To: Kristopher Byrd, Well Construction and Compliance Section Manager
From: Joel Jeffery, Well Construction Program Coordinator
Subject: Review of Water Right Application G-18519
Date: July 25, 2018

Application # G- 18519

TO: Water Rights Section Date 7/17/2018
 FROM: Groundwater Section Joe Kemper
 SUBJECT: Application G- 18519 Supersedes review of NA
 Reviewer's Name
 Date of Review(s)

Figure 2. Well Location Map

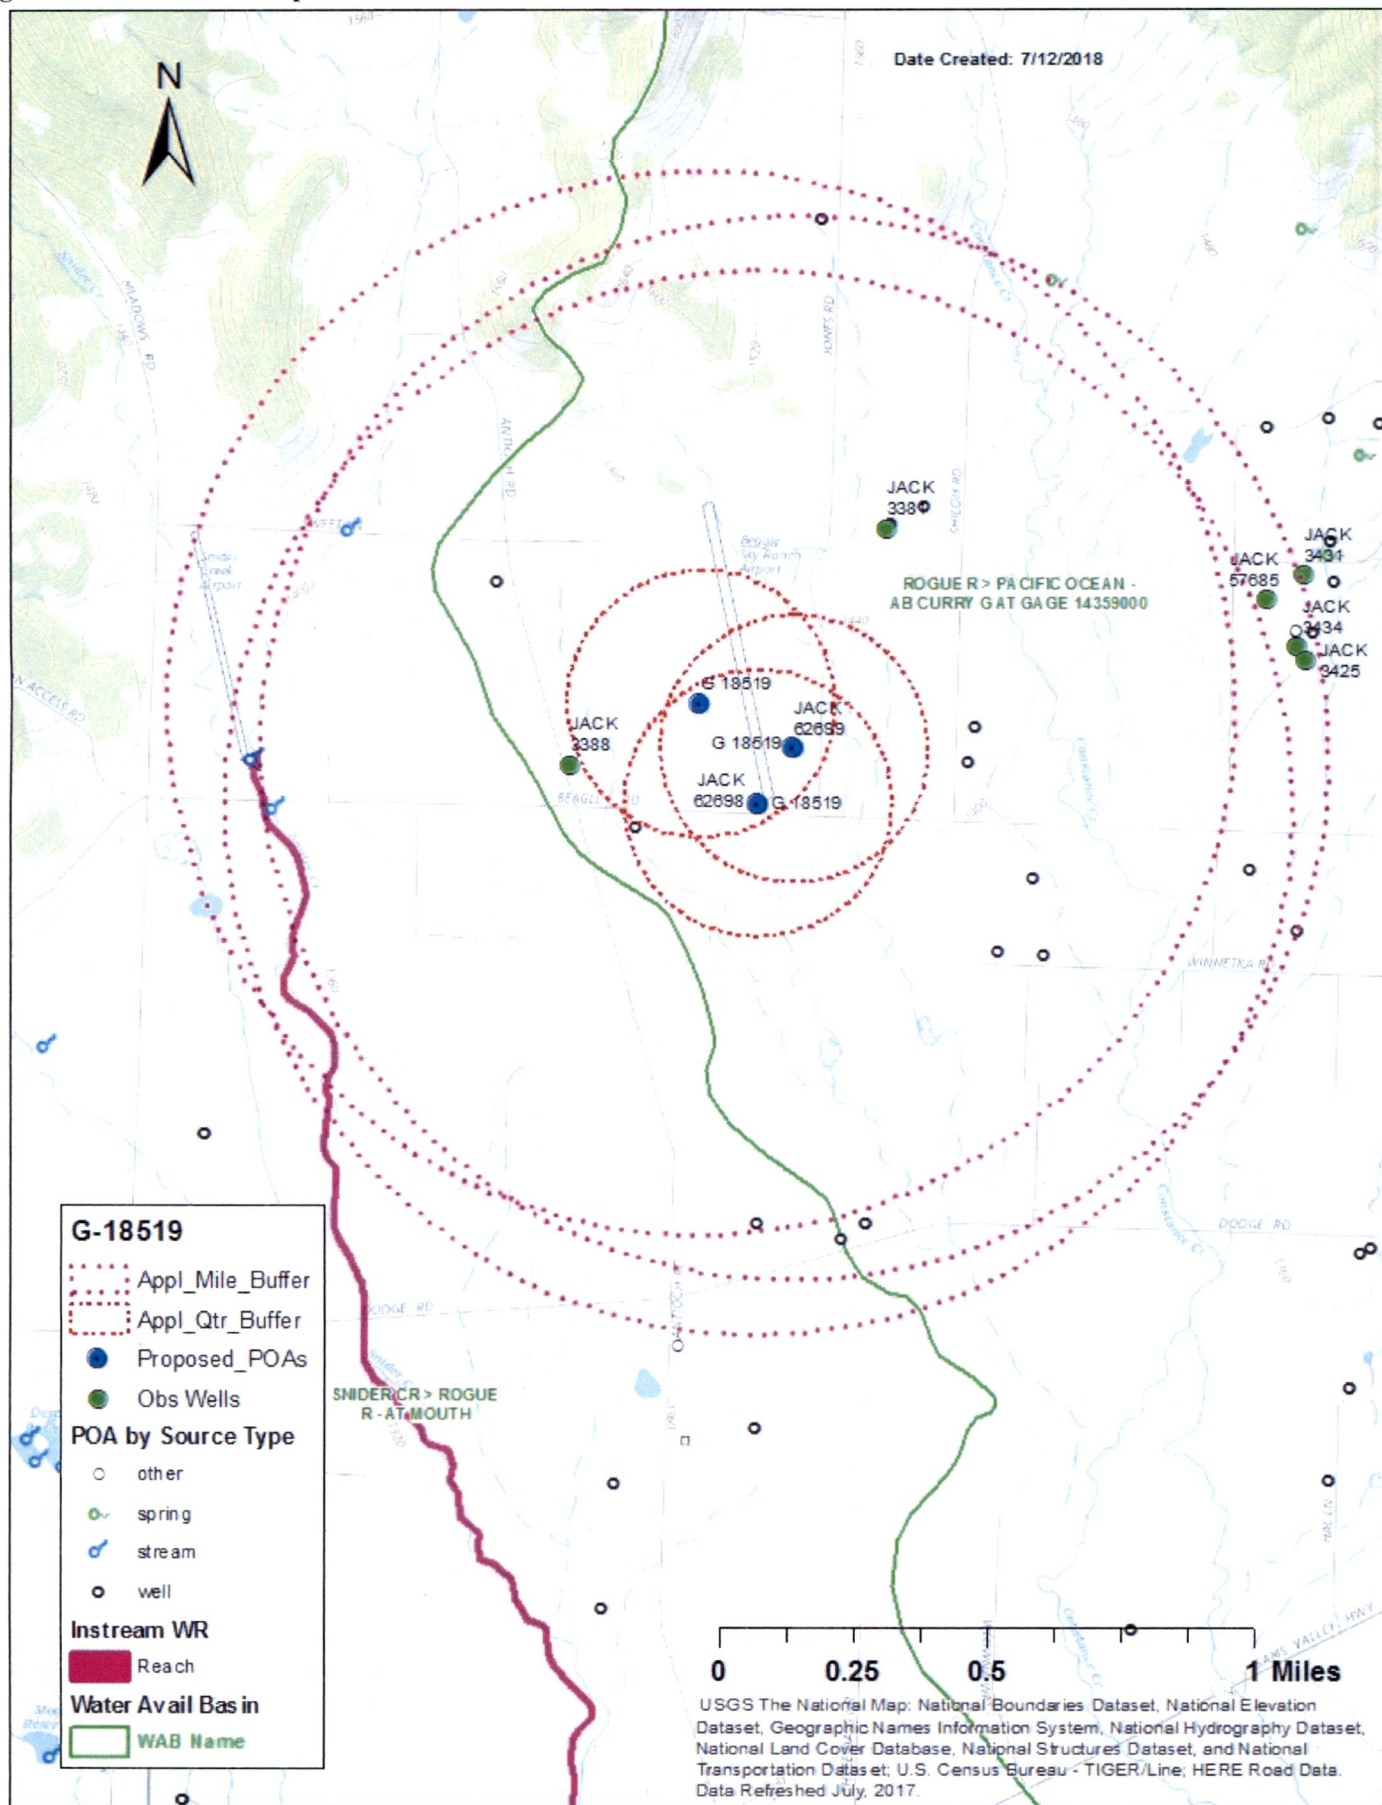
Basis for aquifer confinement evaluation: The well logs for the applicant's wells report "First Water" at 212 feet BLS and 67 feet and a SWL of 40 feet and 26 feet BLS, respectively. Adjacent well logs report similar confined conditions. The reviewer assumes that Well 3, when drilled, will encounter similar hydraulic conditions.

**Well 3 is proposed. The reviewer assumes that Well 3, when drilled, will encounter similar hydraulic conditions.

Figure 3. Water-Level Trends in Nearby Wells

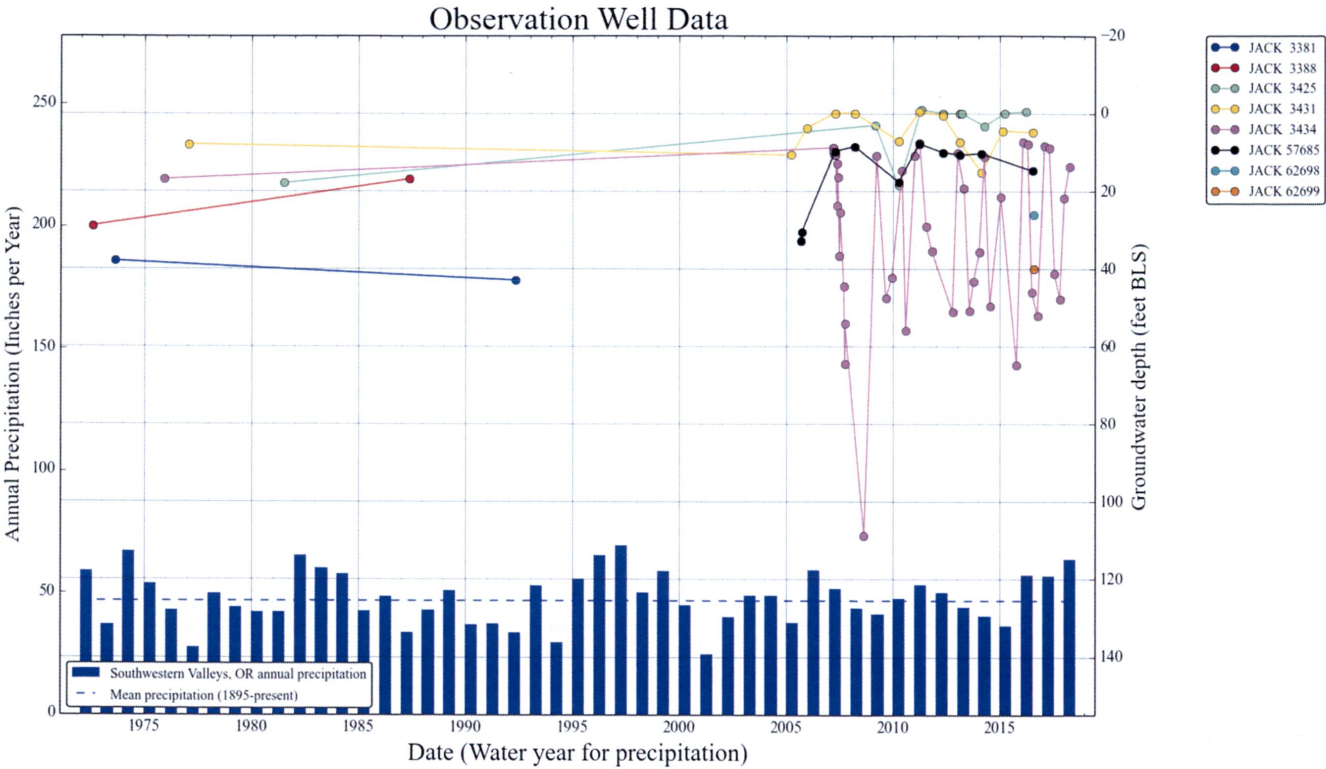
- B3. **Groundwater availability remarks:** The applicant's proposed POA will be producing from fractured bedrock of the Payne Cliffs Formation. Wells in this aquifer system typically produce less than 50 gpm. There are no current OWRD observation well data within 1 mile of the proposed POA so aquifer over-appropriation cannot be determined. However, a cluster of observation wells accessing the Payne Cliffs Formation 1-2 miles to the east shows relatively stable water levels over the previous 10-20 years (see Figure 3).

There are several valid POAs within 0.5 miles of the applicant's wells, posing the risk of injury to senior water rights. However, adjacent taxlot density (as a proxy for well development) is moderate and the Department is unaware of any historic interference problems. Similarly, the above mentioned cluster of observation wells has similar development density, and water levels do not show systemic decline. As such, it is unlikely that the proposed use at the rate requested will cause injury to adjacent senior users.
